Amendment to the Drawings:

Frank Reidy
PERMANENT PIPE IDENTIFICATION TAG SYSTEM
AND METHOD OF USING THE SAME
Attorney Docket No.: 89751.139601
Replacement Sheet

Fig. 2

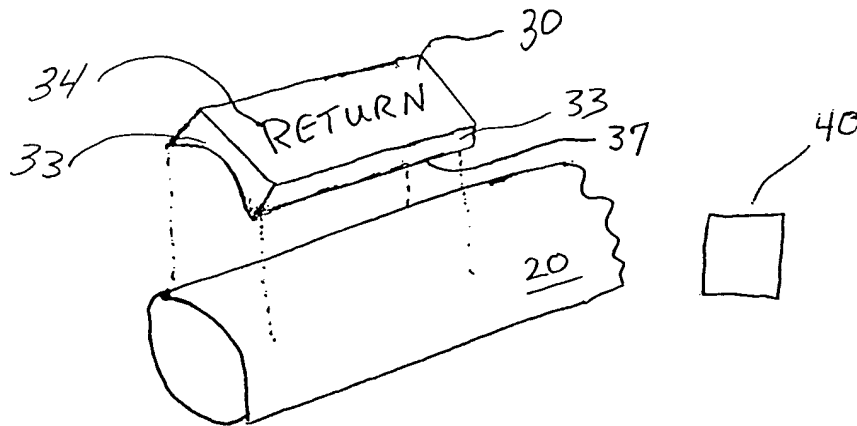
The attached sheet of drawings includes changes to Fig. 2. This sheet, which includes Fig. 1-2, replaces the original sheet including Fig.1-2. In Fig. 2 the previously omitted element 40 has been added.

37 CFR 1.83(a), recites in part, "conventional features disclosed in the description and claims, where their detailed illustration is not essential for a proper understanding of the invention, should be illustrated in the drawing in the form of a graphical drawing symbol or a labeled representation (e.g., a labeled rectangular box). Labeled rectangular box 40 is hereby added to represent the adhesive bonding agent.
